PUBLIC UTILITIES COMMISSION

Subject: Salt Creek Substation—Review of Minor Project Refinement Request #5

SDG&E Minor Project Refinement Request for Change in Location of Fire Service Lateral Line (MRP Request #5)

Subject: Revised Minor Project Refinement Request for Change of Fire Service Lateral Line Location (MPR #5)

Change in Location of Fire Service Lateral Line Figure

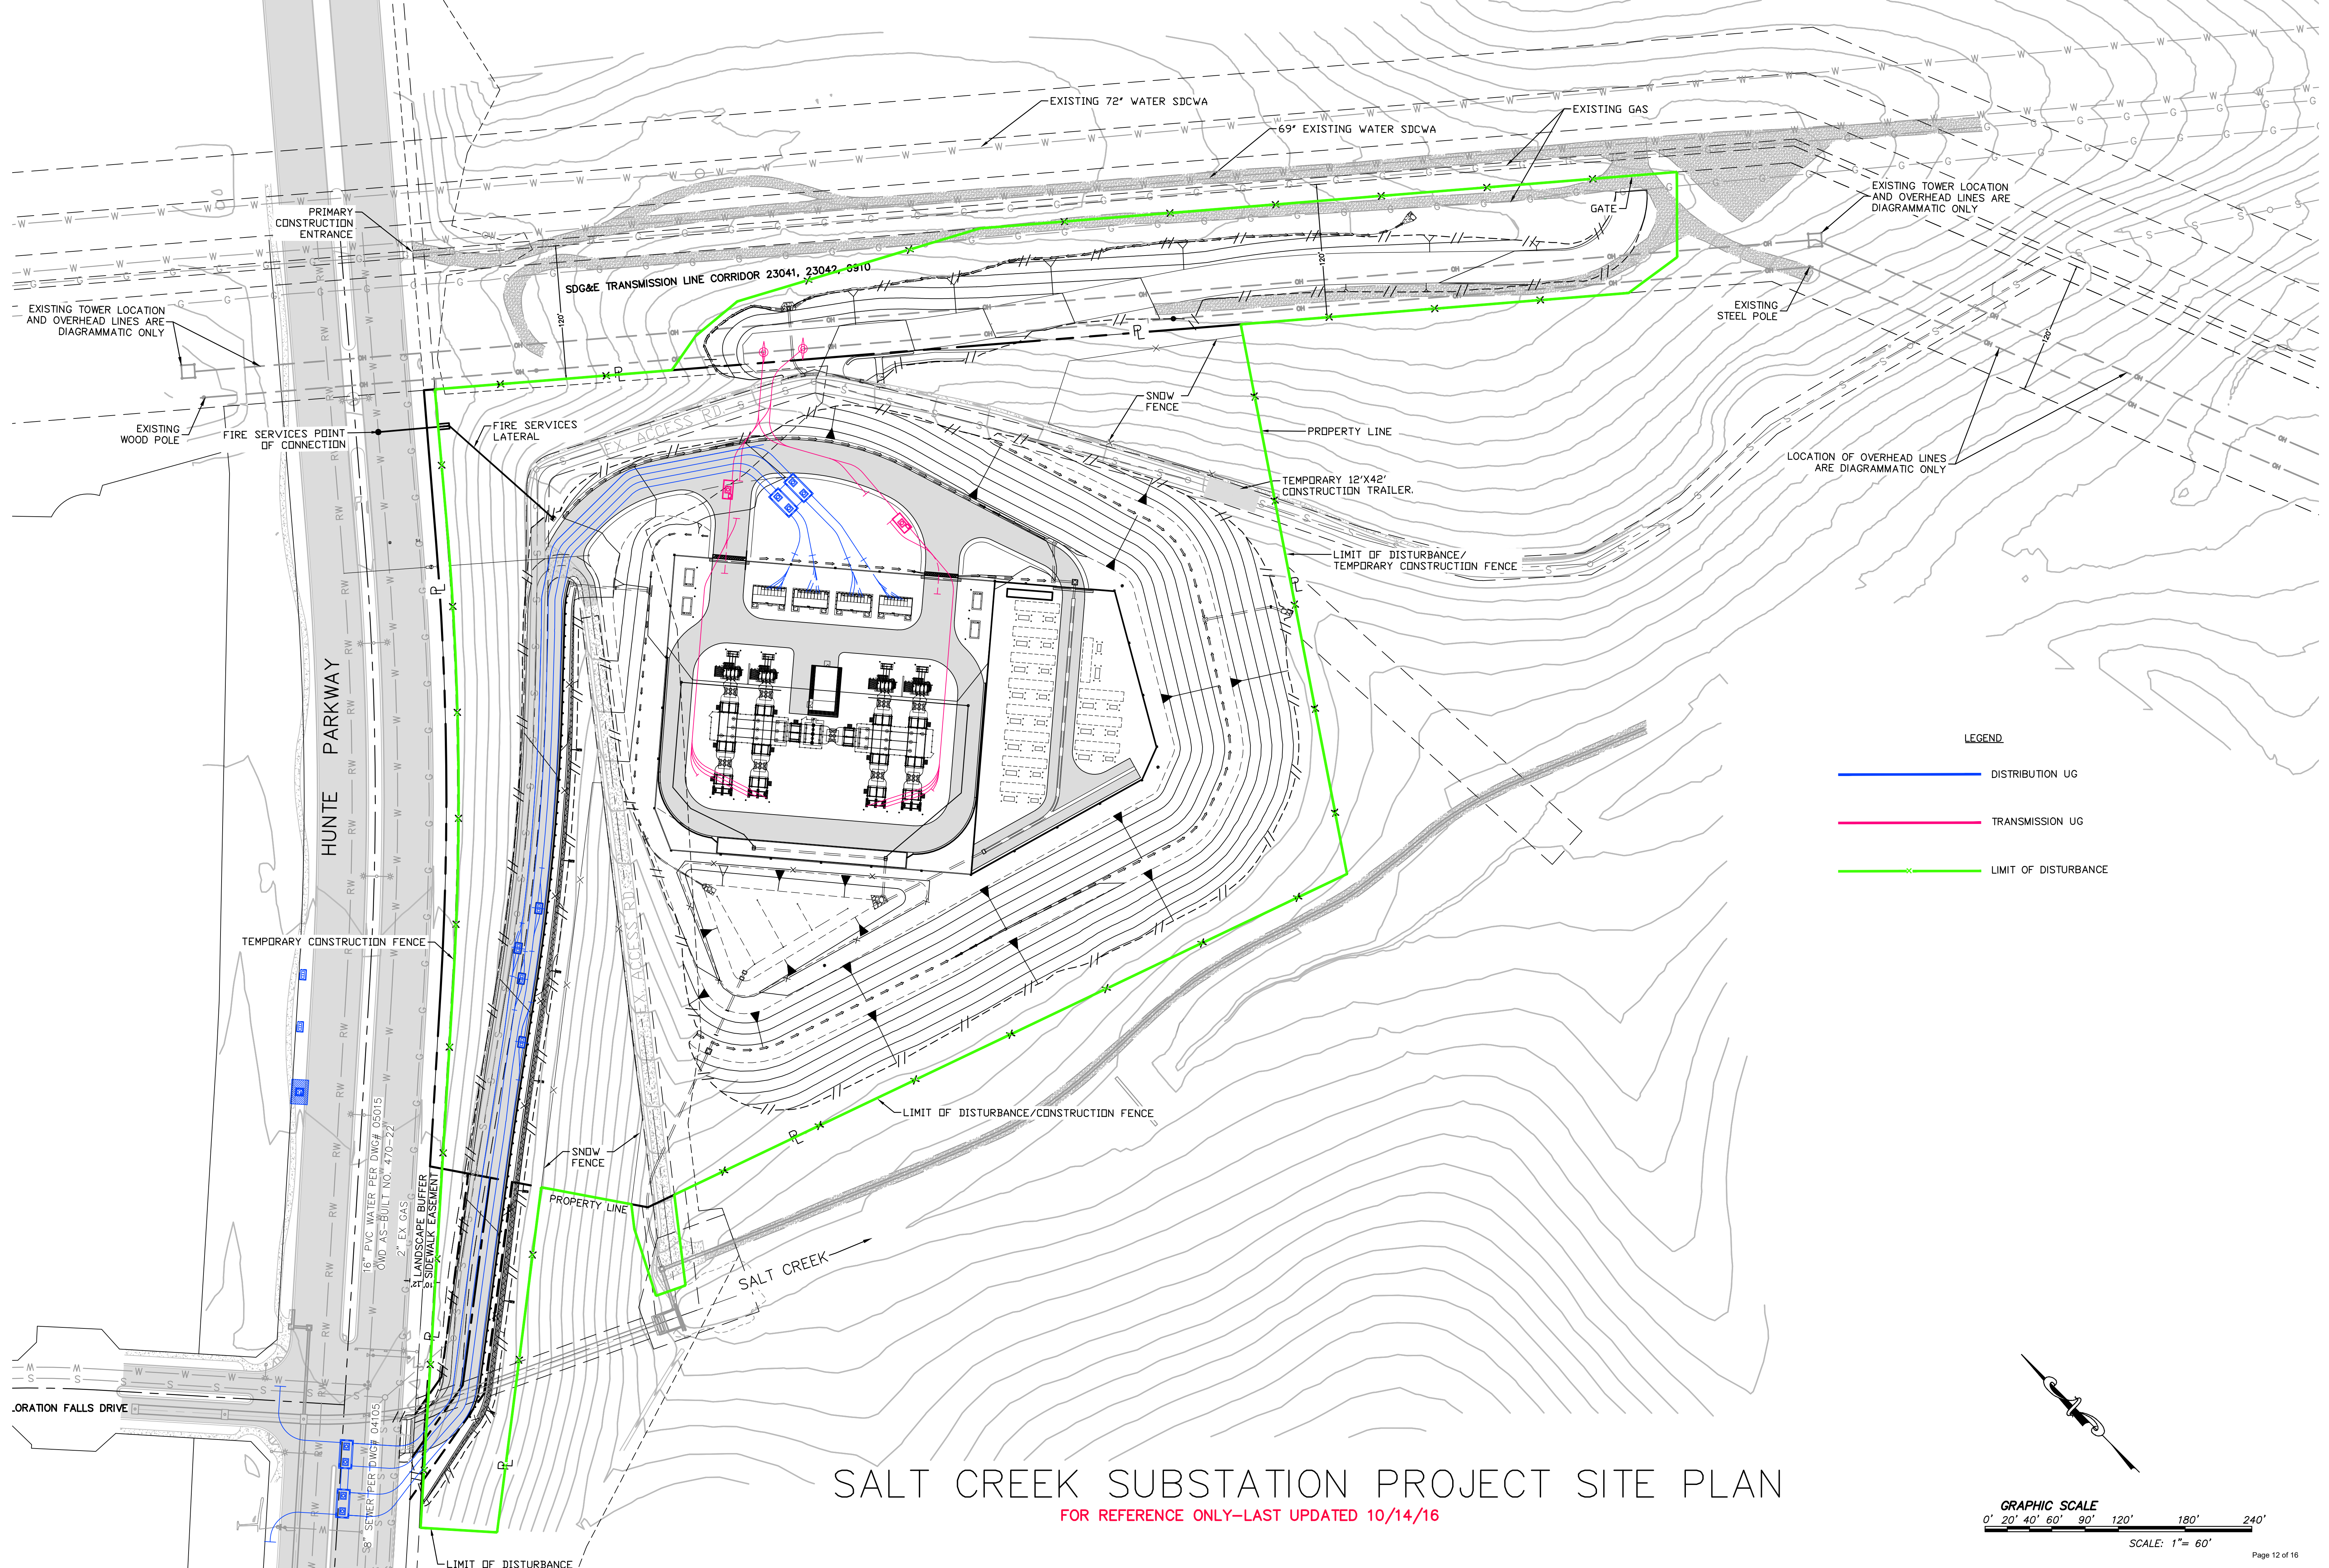
Change of location approximately 100 feet northeast of the fire service lateral line approved in MPR #1.

Since the area is relatively flat 100 feet to the northeast, soil can be placed behind the thrust blocks enabling the backflow preventer to resist forces from the water changing directions, preventing damage to the pipe.

**ATTACHMENT 1 – Change in Location of Fire Service
Lateral Line Figure**

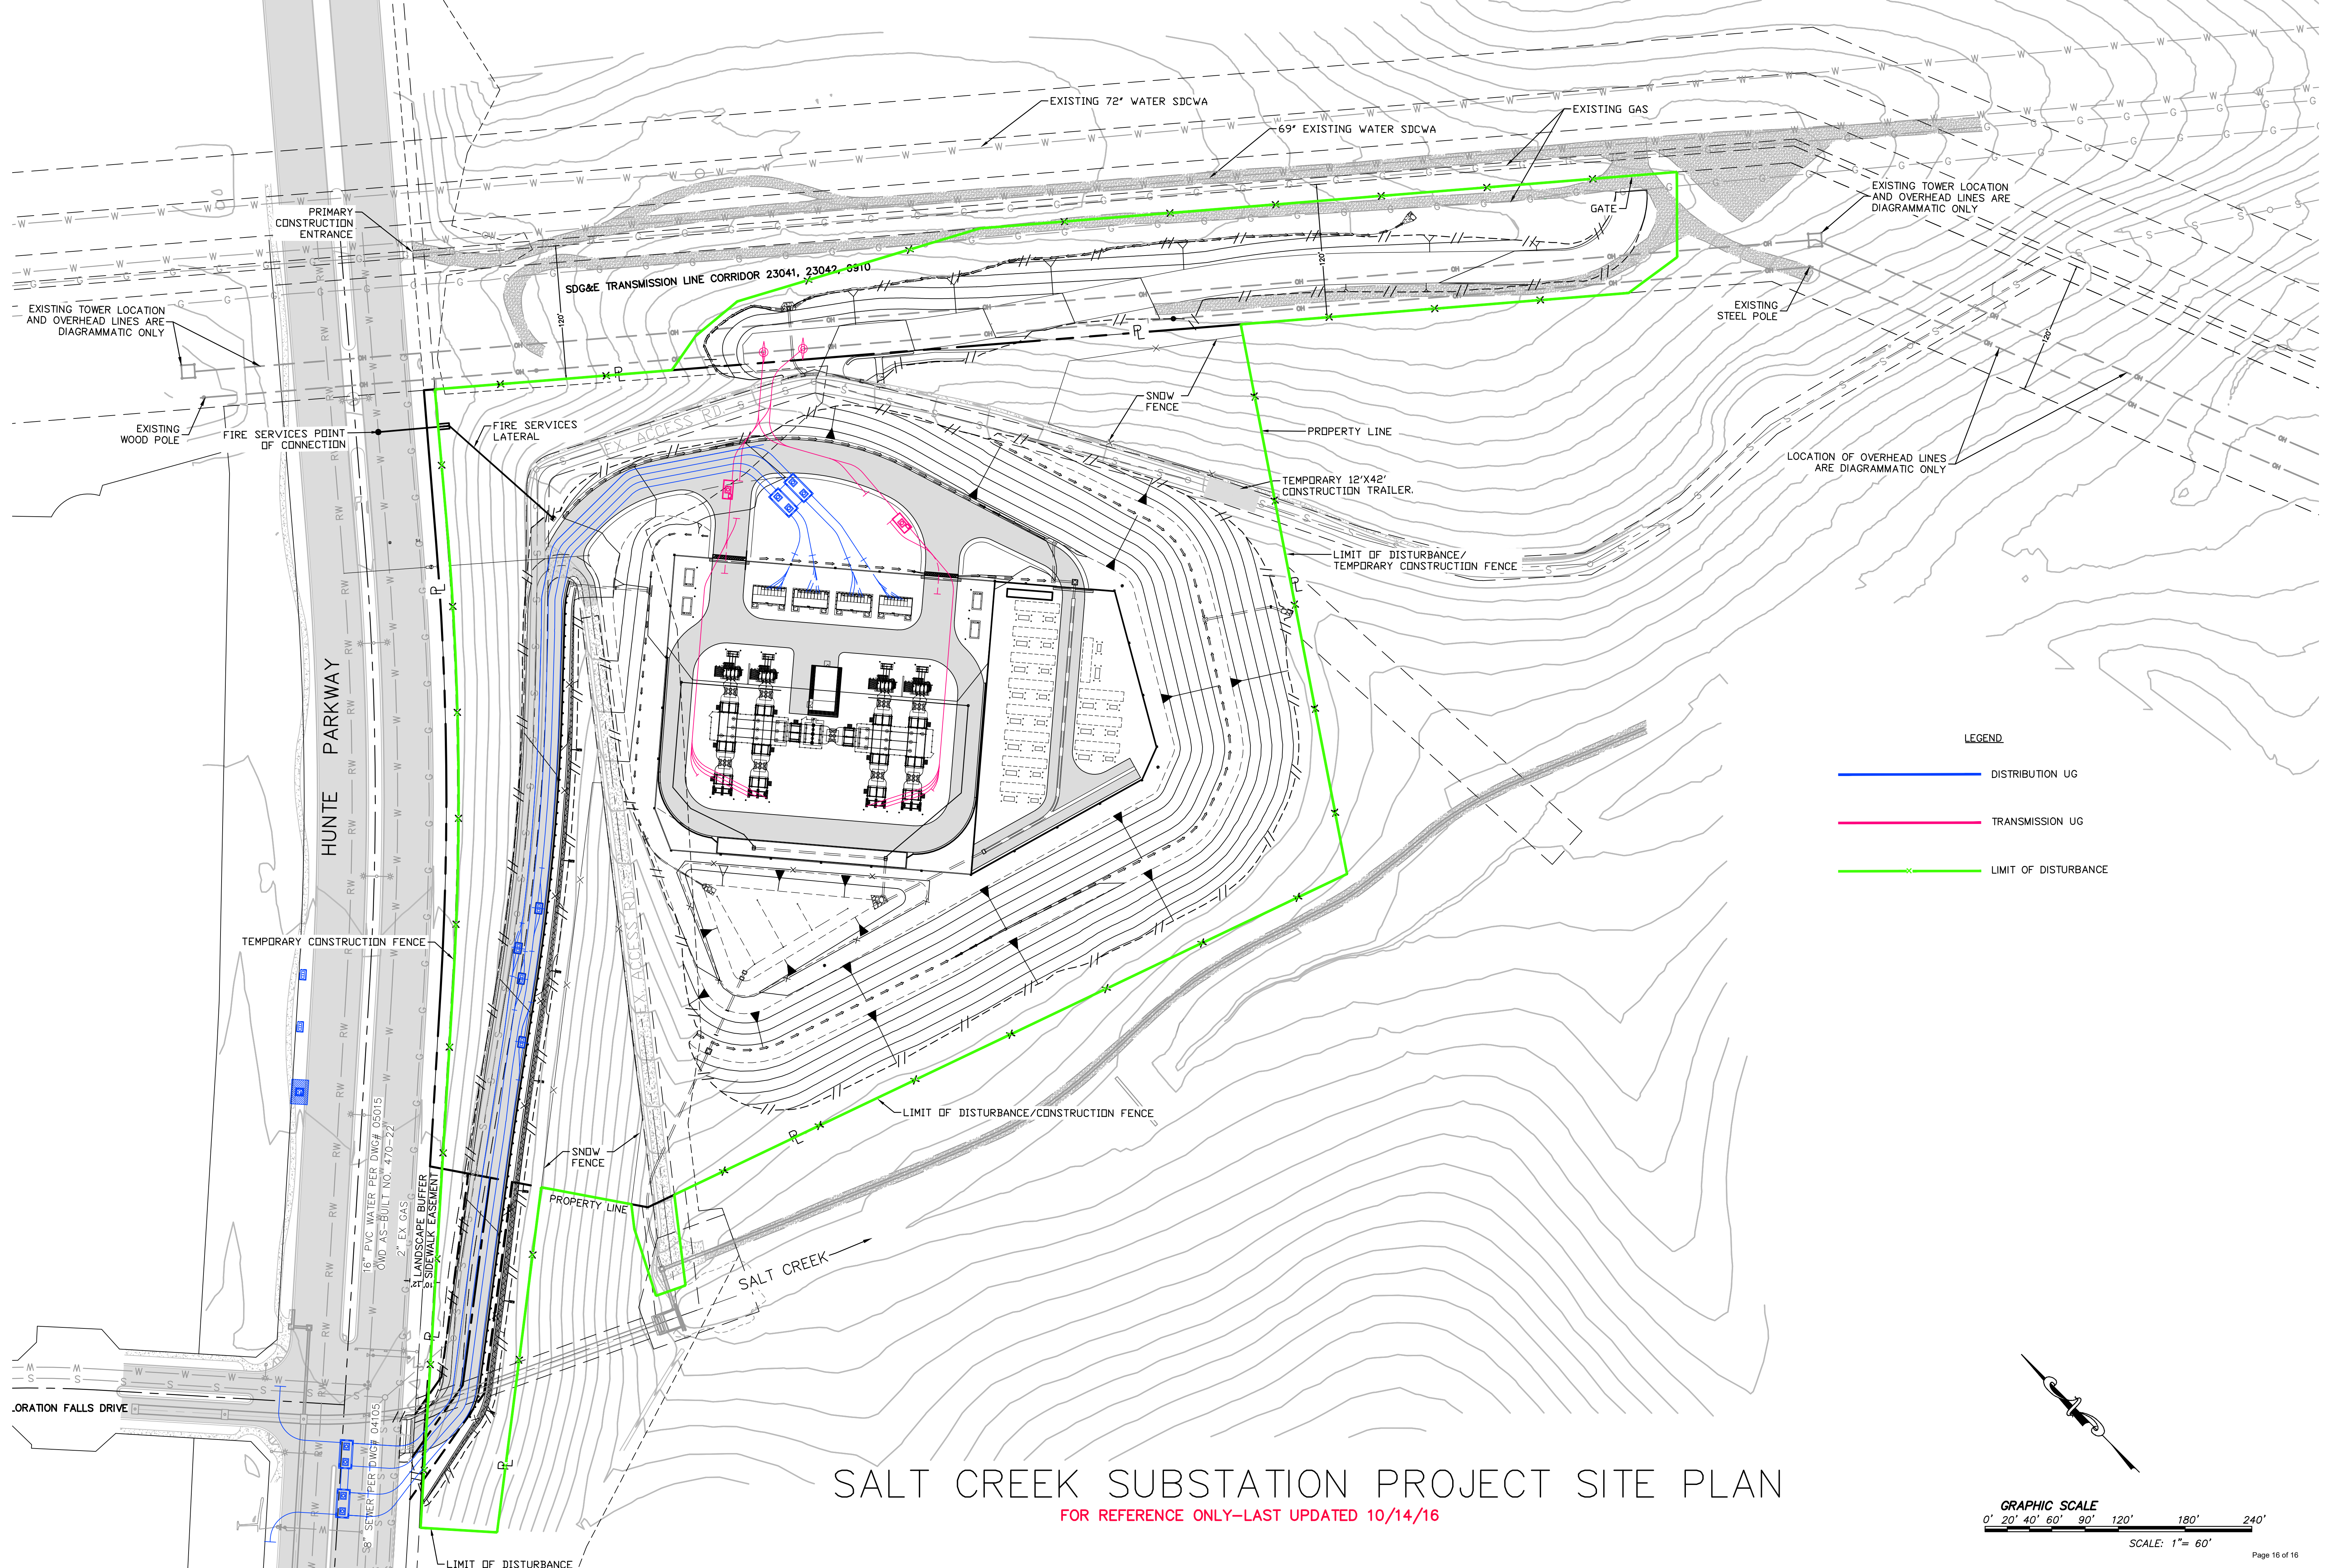
The new proposed location of the fire service lateral line is approximately 100 feet northeast of the originally proposed location that was approved through MPR #1. The new location crosses the property boundary closer to the transmission corridor within the approved/amended and installed temporary construction fence. The new total length of the fire water service lateral would be 191 ft. Approximately 45 ft. of the fire water service lateral would be trenched outside of the property (30 ft. would be trenched in asphalt on Hunte Parkway and 15 ft. would be trenched in the landscaped parkway adjacent to Hunte Parkway) and 146 ft. would be trenched inside the property (131 ft. would be trenched in the landscaped slope and 15 ft. would be trenched in concrete). The trench width would be 3 ft. for a total trenched area of approximately 573 sq. ft. The approximate construction duration for the fire water service lateral would be 6 days.

The new proposed location of the fire service lateral line would be within the LOD approved through MPR #1 and no additional environmental impacts would occur as a result of this MPR #5.

The attached figure (Attachment 1) shows the new location of the fire service lateral line.
